**Project:** NW Bicester  
**Client:** Firethorn Trust

## **Summary of Correspondence with OCC since the Planning Application was Submitted**

Project Title  
**NW BICESTER**

Drawing Title  
**A4095 HOWES LANE/ BUCKNELL ROAD  
 PROPOSED JUNCTION  
 GENERAL ARRANGEMENT**

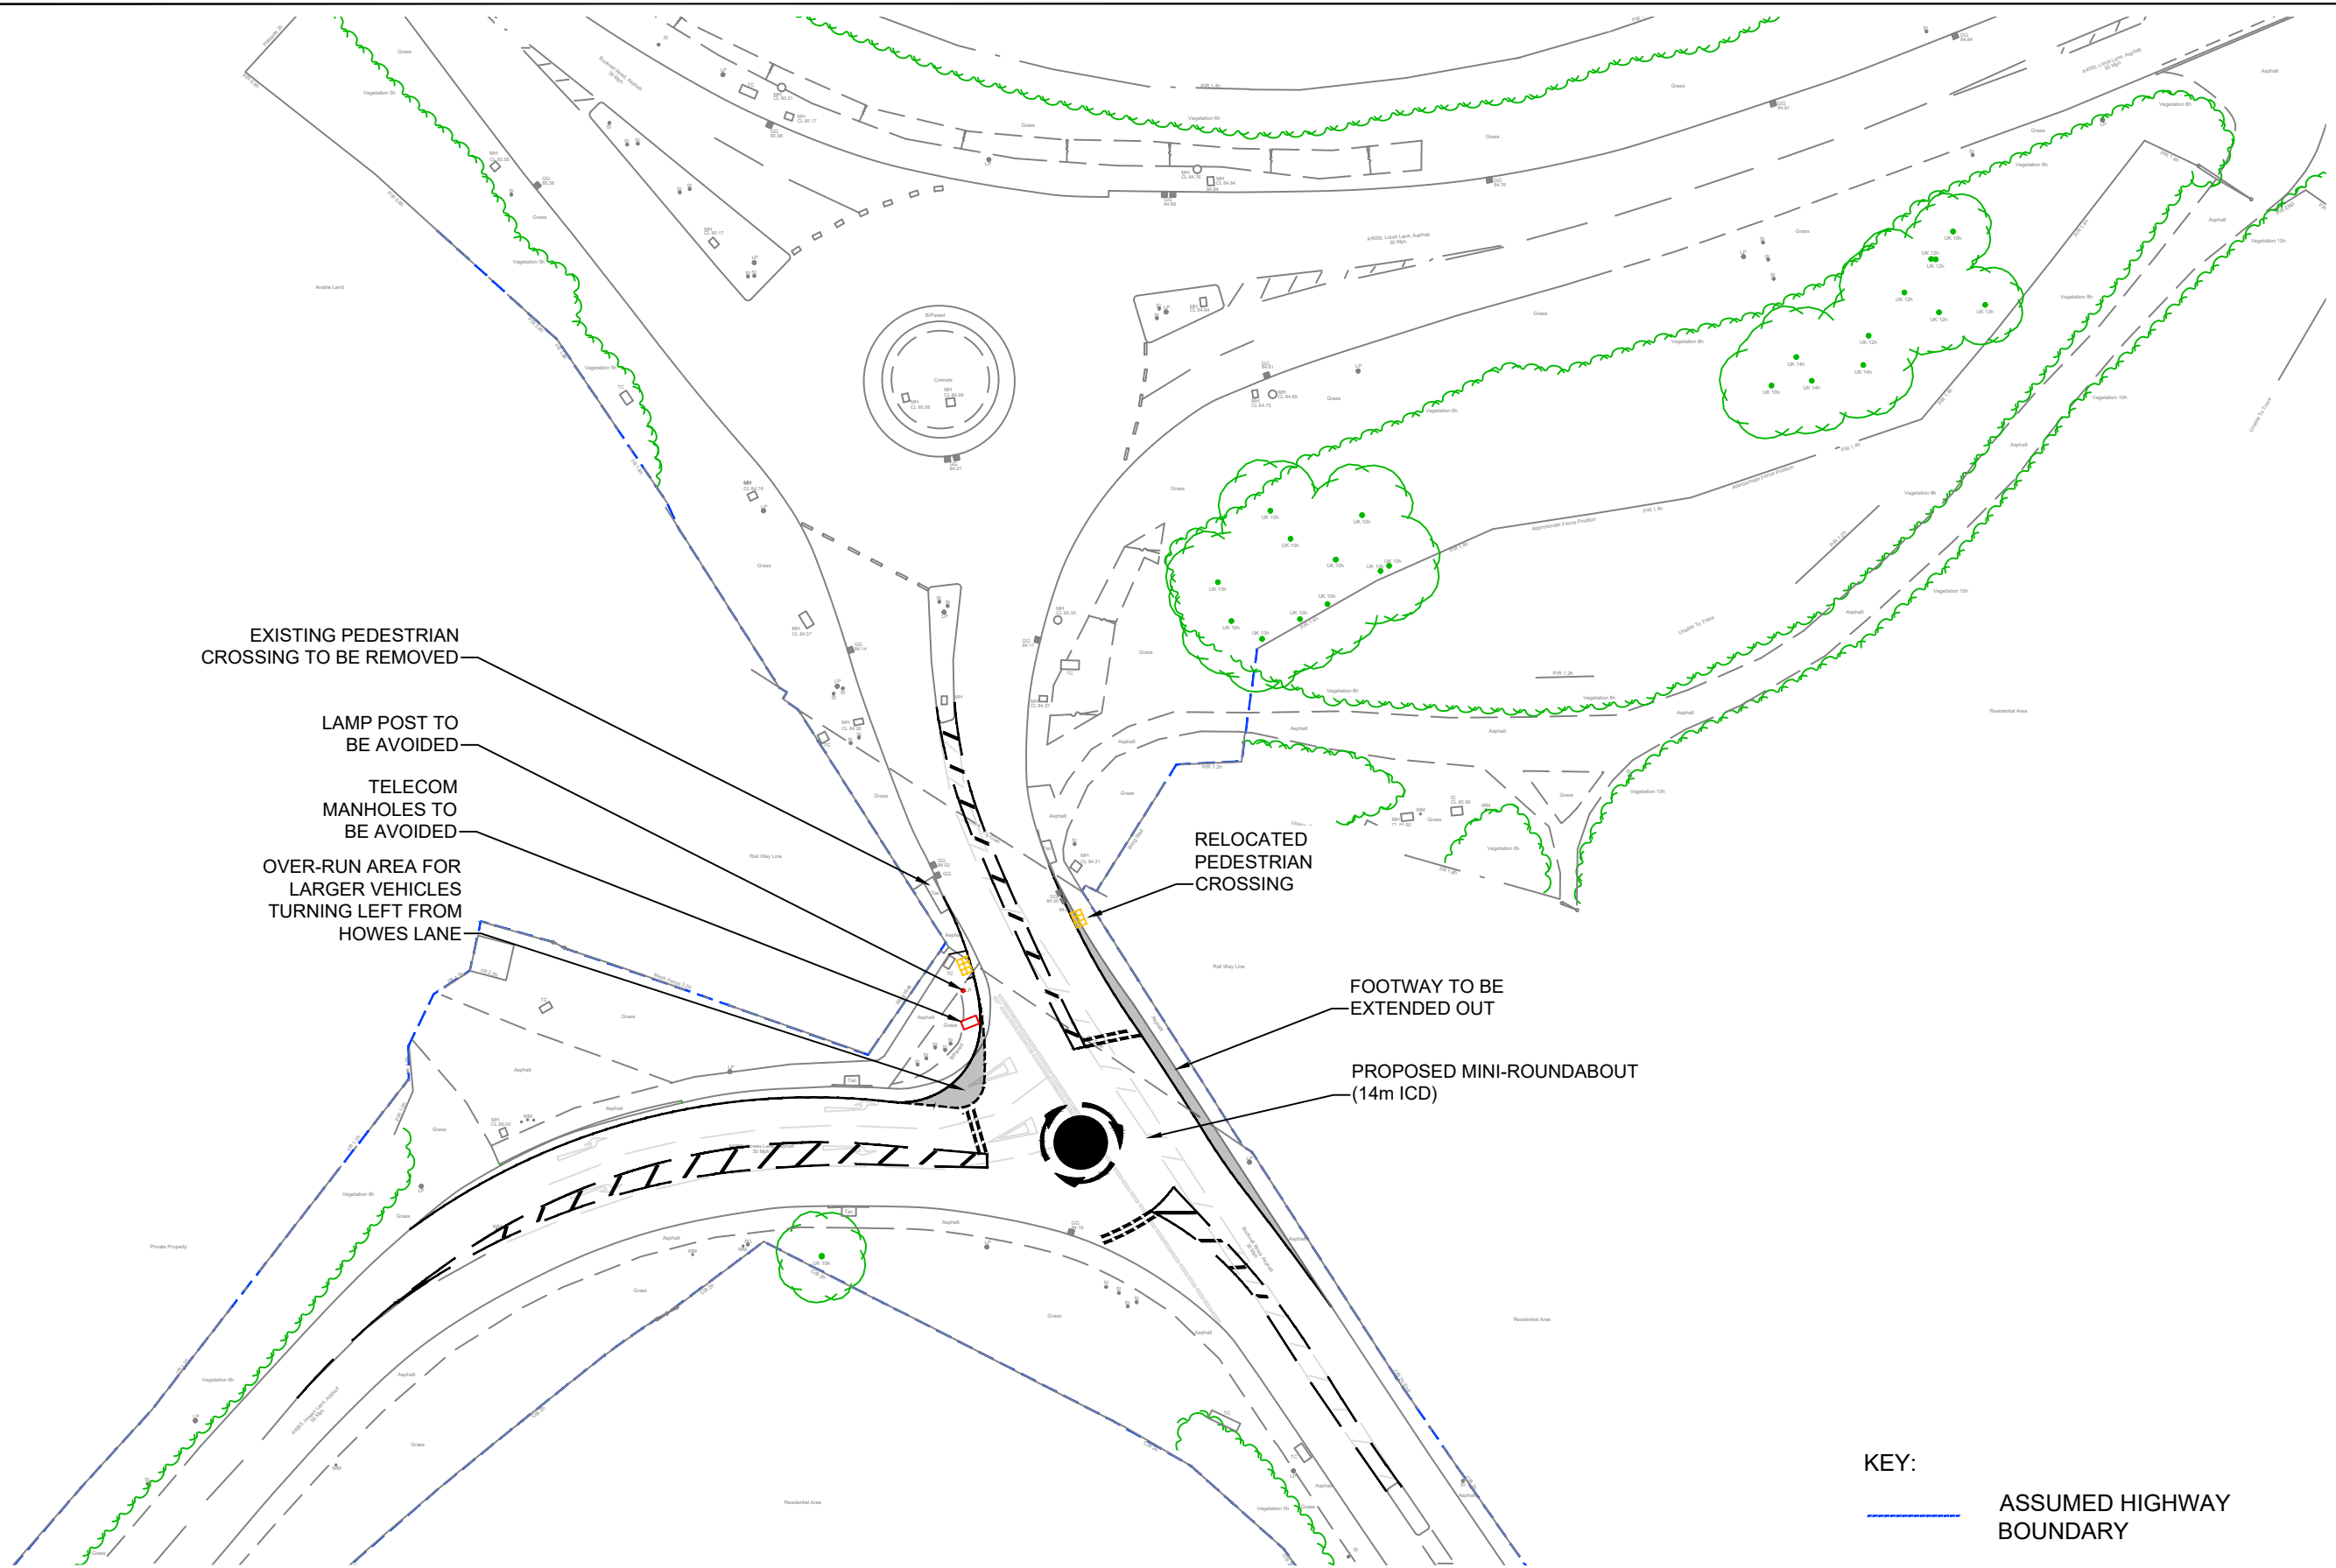
- 3.3. The existing tee-junction and the proposed mini roundabout models (ARCADY and PICADY) are different programs and the way that traffic gives way to certain movements will change. For example, the right turn movement into Howes Lane in the existing junction would have to give way to the northbound traffic on Bucknell Road – this is reversed with the proposed roundabout scheme. To use a 14% reduction in traffic flows and duplicate this method for different types of junction models cannot be considered an acceptable and should not be used in assessing the future impact at the mini-roundabout junction.

- 3.4. A more representative set of capacity results for the mini-roundabout scheme would be to use unadjusted flows on Bucknell Road (North) and allow the ARCADY model to calculate the capacity / queues on the roundabout approaches and compare these to the calibrated PICADY results in Figure 1. Whilst these results were provided by VTP in TN08; they were not used to compare the impact of the new junction scheme. A copy of the unadjusted flow results is included in Figure 2 and copy of the calibrated results is included in Figure 3.

- 4.4. The findings of the VTP ARCADY modelling results (Table 2) suggest that the implementation of a new mini-roundabout scheme (in its present form) would only marginally improve capacity at the junction and does not provide a nil detriment impact for the development traffic. On some approaches, the queues that are generated by the roundabout are longer than the predicted queues at the existing junction due to the different way the streams of traffic give-way.
